Amendment C231 - Queens Parade - Response to submissions

Amendment C231 - Queens Parade - Response to submissions

Trim Record Number: D19/76352

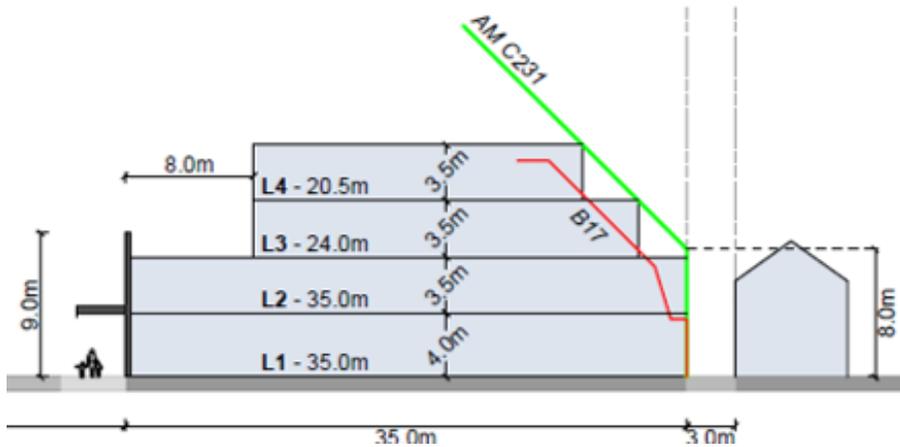
28. Their concerns related to the appropriateness of building heights, particularly in precinct 4 and the adequacy of upper level building setbacks and their impact on visibility of new additions.

29. In particular, submitters want new development in precinct 4 to not be visible from the opposite side of Queens Parade, which has a 60 metre width.

38. In response to the submission and the further testing undertaken, it is recommended that building heights are reduced from 6 storeys mandatory to 4 storeys mandatory as illustrated in the table below.

39. Officers note that 6 storeys was intended as an overall building height 'cap' to prevent excessive development and it was not intended to indicate that every site could be built to 6 storeys. Given the mix of property sizes and constraints, buildings would most likely range in height from 4-6 storey. However, officers consider that the additional testing that has been undertaken for this precinct shows that a 4 storey height can be justified as it reduces the visual impact of new development and better respects the heritage significance of the building façades as they present to Queens Parade. It is considered that the height reduction would not substantially reduce the development capacity of the wider Queens Parade activity centre (given larger scale development is occurring in precincts 2 and 5 and on the Gasworks sites). The recommended changes would give greater weight to heritage, but balance this with reasonable development capacity.

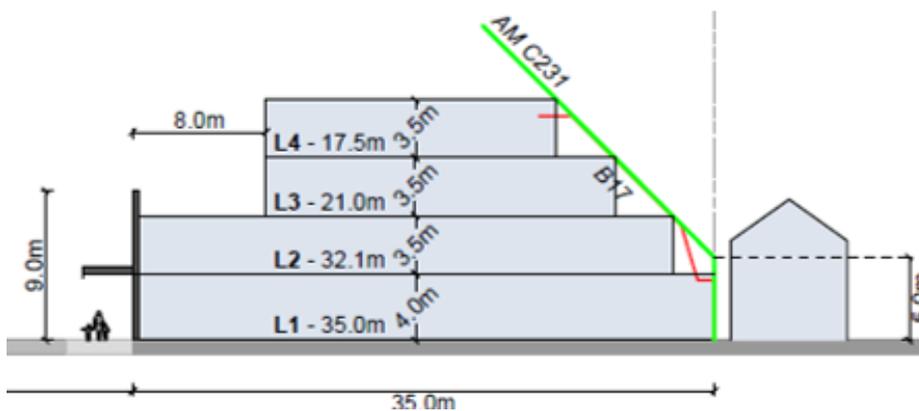
46. A number of submitters, particularly in Hodgkinson and McKean Streets that directly adjoin the centre expressed concerns about the impacts of 6 storey development on their amenity. Key concerns were overlooking, building bulk and overshadowing.
47. The exhibited amendment proposed the following rear setbacks:
 - (a) In the case of a (commercial) property with a laneway to the rear: the building can be built to a height of 8 metres on the boundary and then is set back at 45°; and
 - (b) In the case of a (commercial) property with no laneway to the rear: the building can be built to a height of 5 metres on the boundary and then is set back at 45°.

48. A number of submissions suggested that the ResCode B17 setback is a better alternative. In the case where there is a laneway that separates the commercial and residential land, the B17 setback line would set development back further (see diagram below). Officers are persuaded that rear setbacks could be amended in a manner similar to B17 to provide improved residential amenity to the rear.

50. Officers support recommending changes to the rear setbacks and consider a standard similar to the setback requirement of B17 would provide improved residential amenity to the rear. Officers also consider that there is a need to provide greater protection for residential amenity in the case where there is no laneway separating the new development on the Commercial 1 land from existing residential development.

51. In the case where there is a laneway separating the residential and commercial land, a modified ResCode Standard B17 setback is proposed. This would enable development up to 4 metres in height to be built on the boundary with the lane. The building would then step back in height away from the boundary. The key change from ResCode is the modified standard provides for a 4 metre commercial ground floor rather than a 3.6 metre ground floor.

52. In the case where there is no laneway, officers recommend a three metre setback at ground level. The modified B17 standard as described above is then applied. The three metre setback would provide the same level of protection provided by a 3 metre laneway.
